ECE/TRANS/WP.29/GRE/61
24 April 2009

Working Party on Lighting and Light-Signalling

**REPORT OF THE WORKING PARTY ON LIGHTING AND LIGHT-SIGNALLING
ON ITS SIXTY-FIRST SESSION
(Geneva, 30 March – 3 April 2009)**

Sheet H10W/1

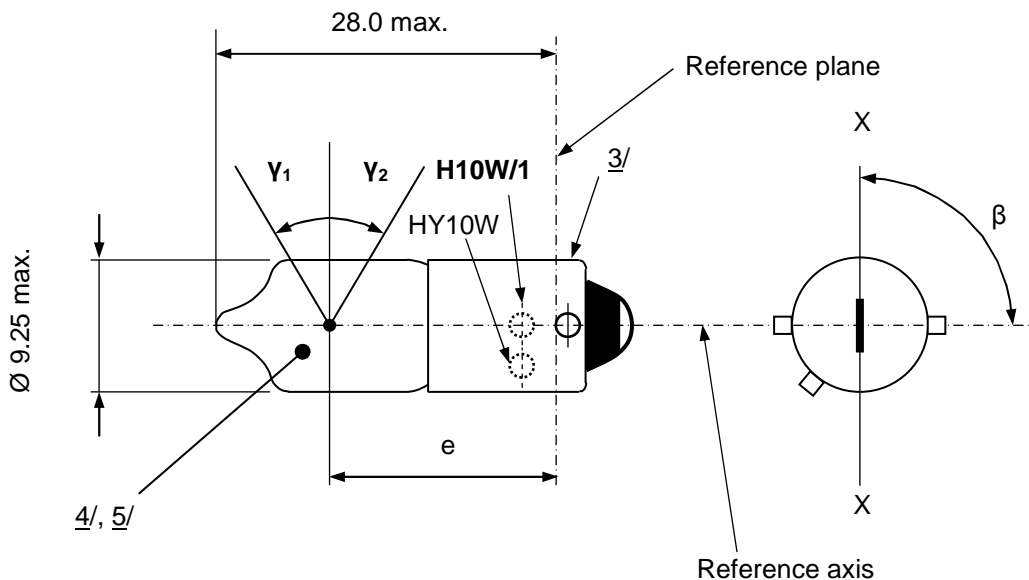
The new sheets H10W/1 to 2, between sheet H6W/1 and sheet H21W/1, amend to read (see next pages):

Dimensions in mm		Filament lamps of normal production			Standard filament lamp
		min.	nom.	max.	
e		14.25	15.0	15.75	15.0 ± 0.25
Lateral deviation	<u>1/</u>			0.75	0.4 max
β		82.5°	90°	97.5°	90° ± 5°
γ_1, γ_2	<u>2/</u>	30°			30° min.
Cap:	H10W/1: BAU9s HY10W BAUZ9s	in accordance with IEC Publication 60061 (sheet 7004-[...]) in accordance with IEC Publication 60061 (sheet 7004-[...])			
ELECTRICAL AND PHOTOMETRIC CHARACTERISTICS					
Rated values	Volts	12			12
	Watts	10			10
Test voltage	Volts	13.5			13.5
Objective values	Watts	12 max.			12 max.
	Luminous flux	H10W/1	200 ± 12 %		
		HY10W	120 ± 17 %		
Reference luminous flux at approximately 13.5 V					White: 200 lm
					Amber: 120 lm

- 1/ Maximum lateral deviation of filament centre from two mutually perpendicular planes both containing the reference axis and one containing axis X-X.
- 2/ In the area between the outer legs of the angles γ_1 and γ_2 , the bulb shall have no optically distorting areas and the curvature of the bulb shall have a radius not less than 50 per cent of the actual bulb diameter.
- 3/ Over the entire length of the cap there shall be no projections or soldering exceeding the permissible maximum diameter of the cap.
- 4/ The light emitted from filament lamps of normal production shall be white for category **H10W/1** and amber for category HY10W.
- 5/ The light emitted from standard filament lamps shall be white for category **H10W/1** and amber or white for category HY10W. "

"ANNEX 3

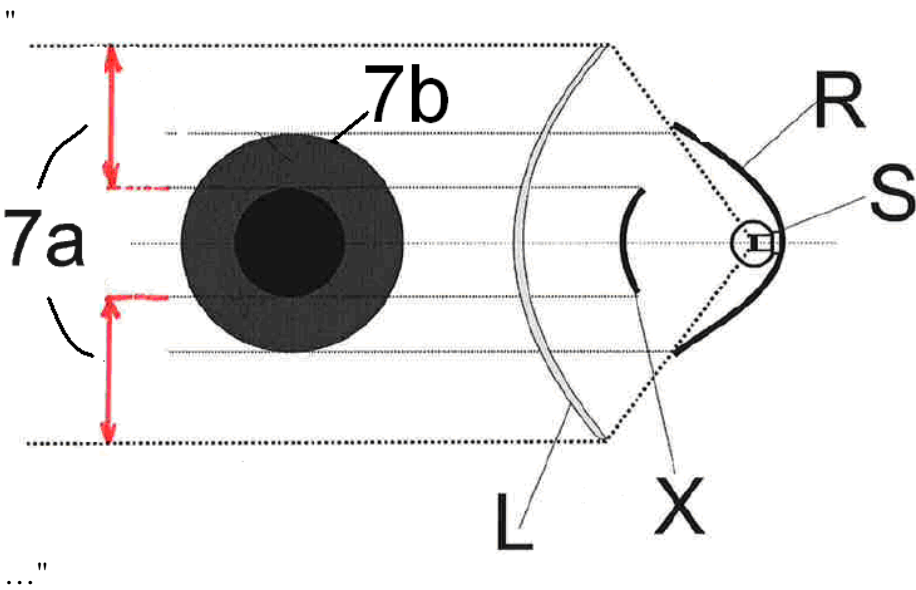
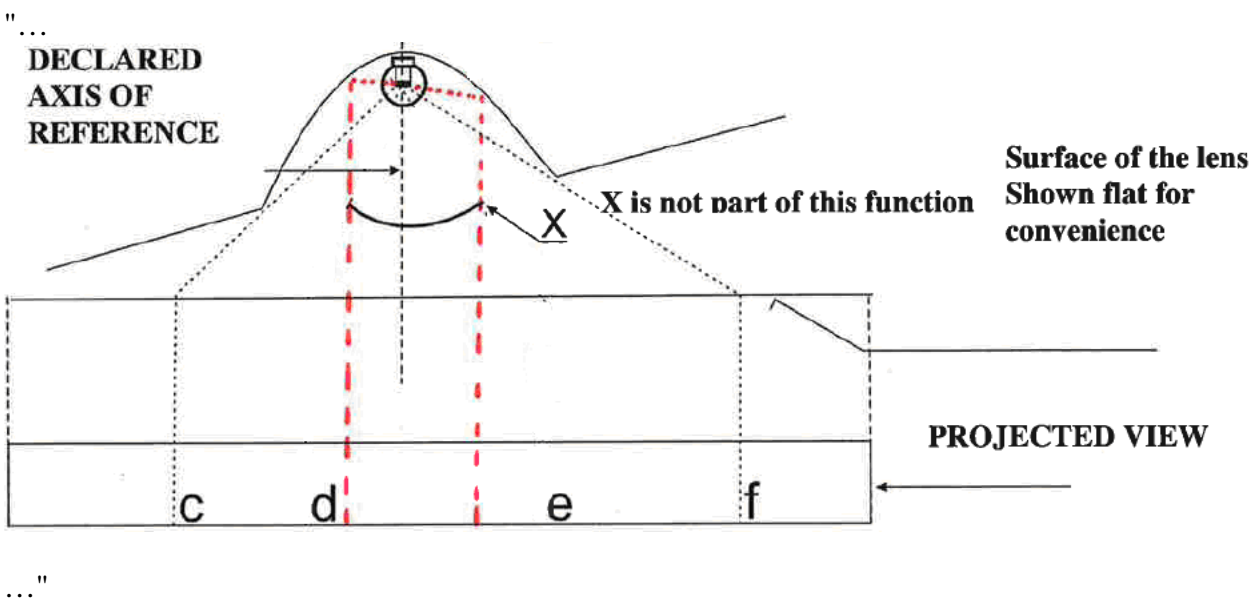
Annex 3, amend to read (to be fully replaced):

**These examples show some arrangements to aid the understanding of the provisions and are
not intended to be design restrictive.**
